**Re: 2770 Baird Road – Perinton Churches Housing Apartments | Midvale
Historic Architecture Application**

This application is to acquire a certificate of appropriateness from this board regarding a project sign located near the entrance of the Midvale Commons facility located at 2770 Baird Road. The planning board has approved the sign location and design on 3/6/2024, with the condition that the applicant receive a CoA from the Historic Architecture Commission.

**Minutes of the Town of Perinton
Planning Board Meeting of 3/20/24
7:30 PM**

Signage: 2770 Baird Road – (tax id# 152.11-2-38) Midvale Commons

CLIENT	CHRISTA / MIDVALE	JOB NO.	MIDV-02
PROJECT	MONUMENT SIGN	DESIGN REV.	0
PROCESS	MONUMENT/DIMENSIONAL	DATE	4/17/2024
			D.C

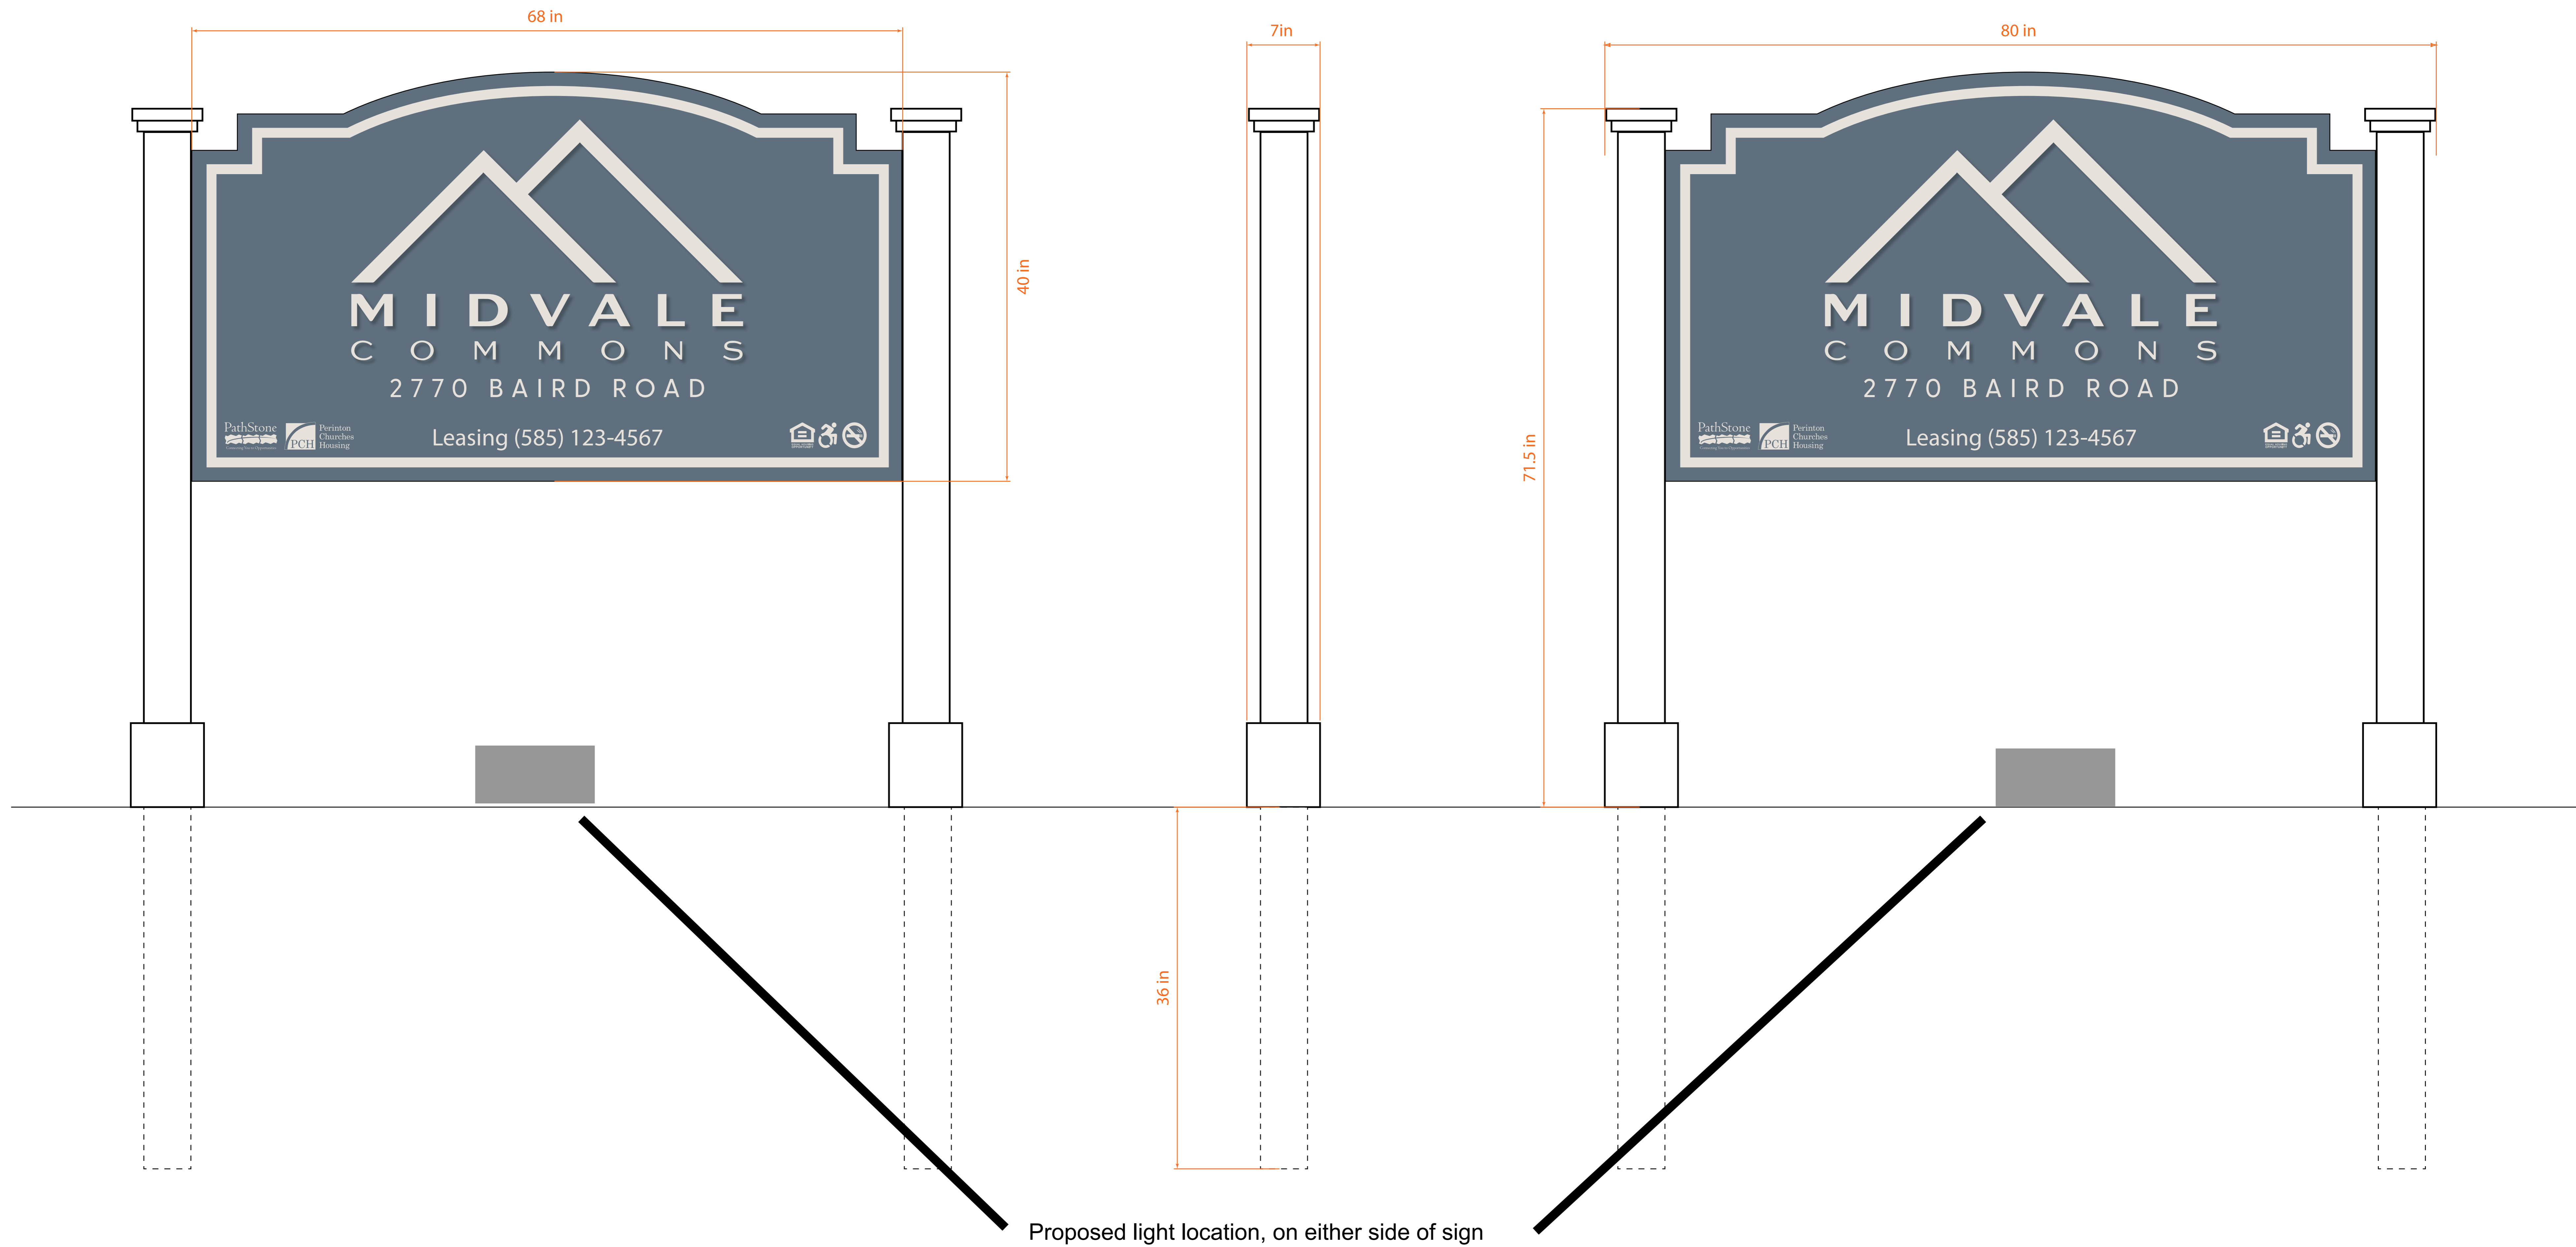
Robert Hannan, 2737 Baird Road, states that he is opposed to the sign because of the color and it's doesn't fit in with the neighborhood and reminds the Board that this is a historic district.

Mr. Brasley states that this is in a historic district and the applicant will need a C of A from the HAC. Mr. Brasley adds that he would like to see the street address number 2770 added to the sign. Mr. Saxton states that he will ask his client to add the number. Mr. Brasley states that he is ok with the color but that is for the HAC to review.

Mr. Gardner states that the sign looks boring. Mr. Gardner states that he would like to see the number 2770 added to the sign. Mr. Gardner adds that a stone base would be nice to see.

Ms. Neu states that the number 2770 should be added to the sign. Ms. Neu states that she does not support the sign due to the incomplete application and the look doesn't fit with a historical district.

Mr. Gulick states that he supports the sign and that the number 2770 should be added to the sign.

Mr. Bradford states that if the sign is going to be lit, then the applicant should add some planters around the base. Mr. Bradford adds that the number 2770 should be added to the sign.

Ms. Kosten states that the number 2770 should be added to the sign and the applicant should work with the HAC to make the sign more aesthetic and to work on the color options.

- 1) Applicant to obtain a sign permit from the Building and Codes Department within 6 months of today's date and prior to sign being erected.
- 2) Applicant shall add the street number 2770 to the sign.
- 3) Applicant shall review the lighting plan with the DPW before erecting the sign.
- 4) Applicant shall obtain a Certificate of Appropriateness from the Historical Architecture Commission before erecting the sign.
